**TOWN OF BAY HARBOR ISLANDS
PLANNING AND ZONING BOARD**

March 2, 2021

1. Request for approval for a new single family home for "1260 95 Street Associates, LLC" located at 1260 95 Street, Lot 5 of Block 32. On September 1, 2020 the Board identified several concerns and deferred the project. The property owner, has resubmitted revised plans addressing the comments. The new proposed two single family home has approximately 5,846 square feet of a/c living space. The residence will have 5 bedrooms and 4 1/2 baths. Enclosed please find the site plan and elevations. (Item #1)

Subject: Single-Family Residence – New Construction
1260 95th Street (Revised per 9/01/20 PZB Comments)
Bay Harbor Islands Acct. No.: SPR19-000004
MMPA Acct. No.: 01-0702-1095

1 NORTH / FRONT ELEVATION
SCALE: 1/4" = 1'-0"

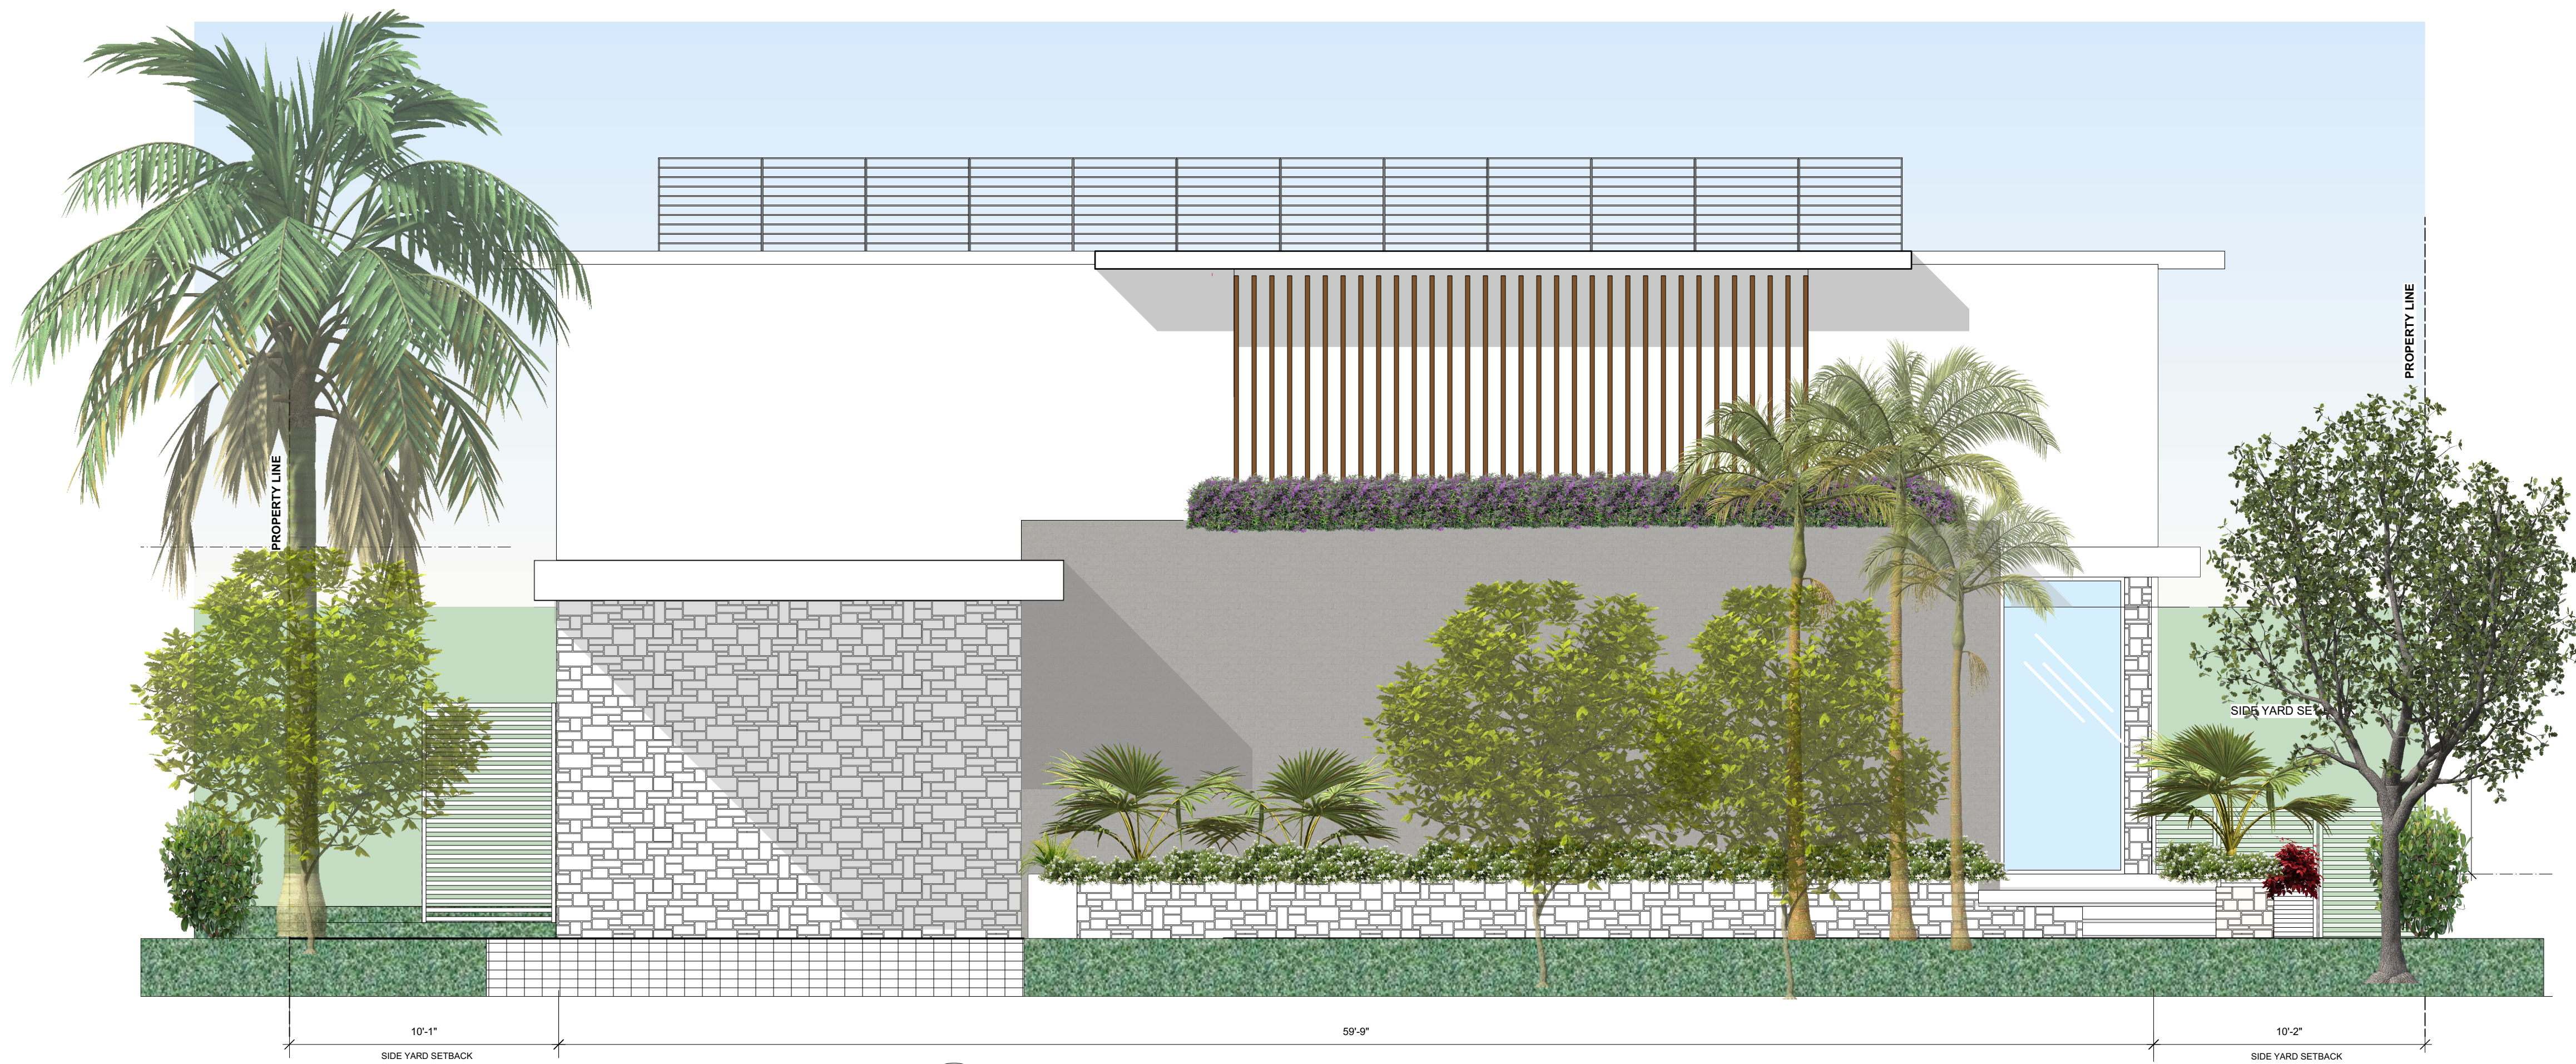
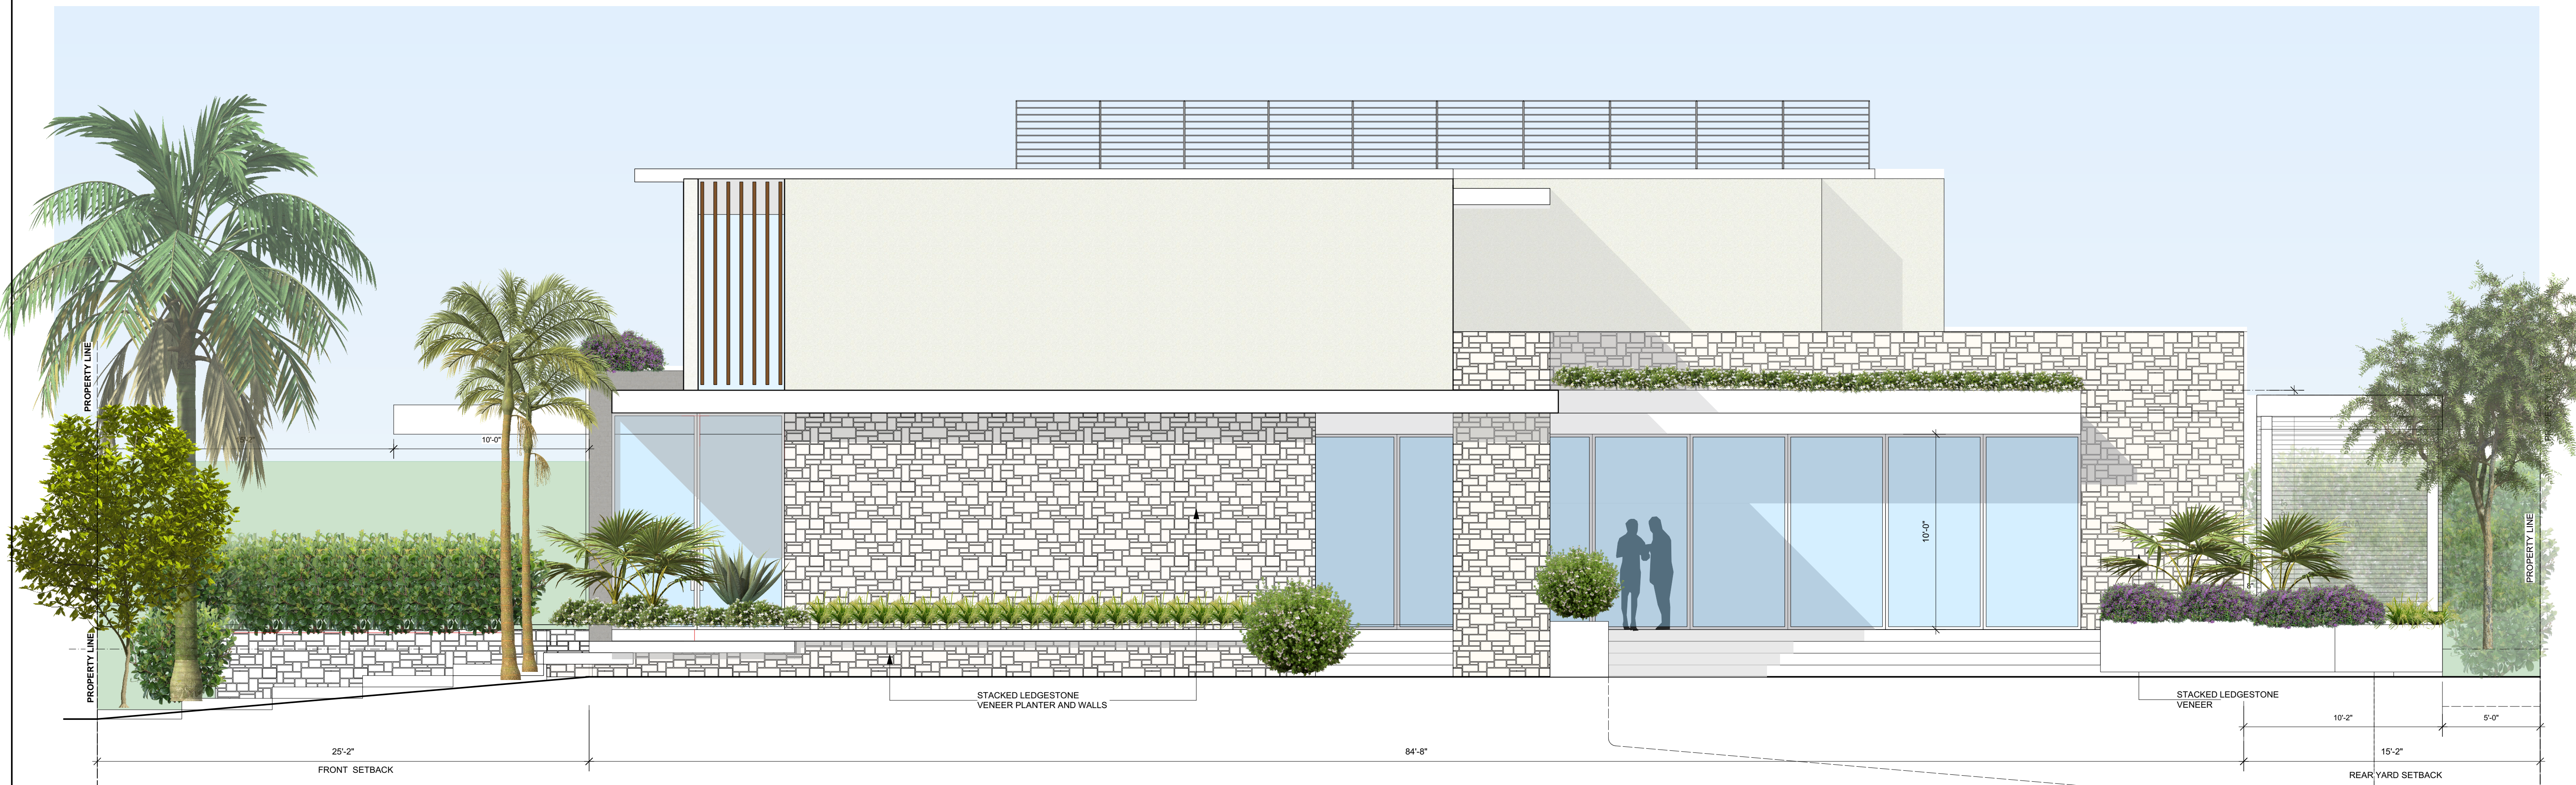
- The Board has a responsibility as to address how these homes and houses have a relationship to the community. Felt this could be achieved with slight modifications, but as currently presented, the project turns its back on the community, because of the big planes of wall that are opaque.

- There is a note in the drawing for cable rail, but there are detail drawings that show horizontal aluminum pickets. The cable rail looks better, because it is much lighter than the heavier design of horizontal pickets.
